Historic Architectural Review Commission
Staff Report for Item 2

To:	Chairman Bryan Green and Historic Architectural Review Commission Members
From:	Enid Torregrosa, MSHP Historic Preservation Planner
Meeting Date:	December 19, 2018
Applicant:	William Shepler, Architect
Application Number:	H18-03-0014
Address:	#903 Eaton Street

New one and a half and two-story wood frame house. New pool cabana, pool, decks, and site improvements.

Two-story height and proportions comparison.

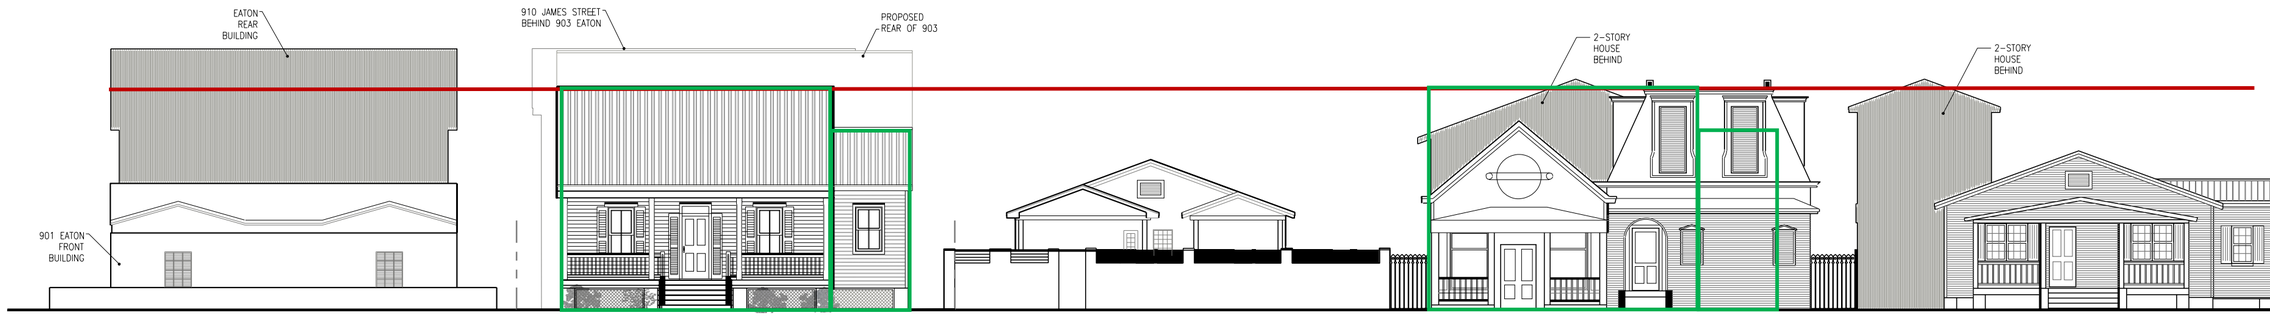
The revisions meet the recommendations expressed by many of the Commissioners during the November HARC meeting. Staff finds that the massing of the structure has reduced by making the connector a one-story structure. Staff still opines that the proportions (relationship of width to height) and scale of the front and rear volumes both, are dissimilar with same land use surrounding historic houses found in the urban block.
